Note in response to Woodland Trust

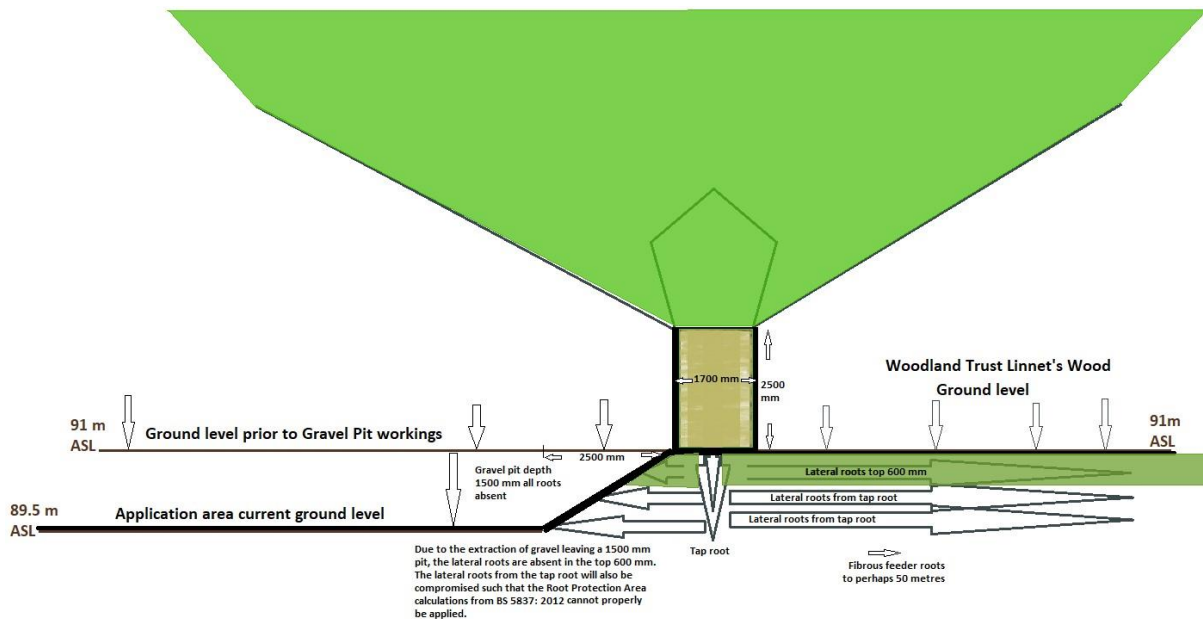
The slope originates at the top of the root plates, so all the lateral roots on the west side of the tree were removed. See diagrammatic section below.

This gravel extraction has therefore destroyed the lateral roots on this side of the tree and that any lateral roots from the Tap root are severely compromised and thus unlikely to be of significant length and notably shorter than BS guidelines would estimate. For this reason, it is considered the root protection zone applied is very conservative and provides a more than adequate buffer.

The assessment of this clearly shows that the root protection is unlikely to exceed the 15m buffer zone. However, it is considered prudent to provide the 5m buffer from the canopy, principally for amenity value. It is proposed to reposition Plots 14, 15 and 16 to allow an expansion of the current buffer zone, the applicant is content therefore for the dwellings in question to be moved slightly to ensure this additional buffer is provided.

In regard these to extracts it is clear that where damage has previously occurred to the root protection zone of a tree that there is an opportunity to mitigate for this and improve the existing soil quality around the tree. It is therefore proposed to build the levels of the gardens up and particular the end of the gardens approaching the base of the tree. This will be beneficial for the long-term preservation of the tree as it will allow lateral roots to establish and help stabilise the trees. This is detailed on the sections showing the gardens of the two relevant plots, which is provided at drawing no 596 x PL24.
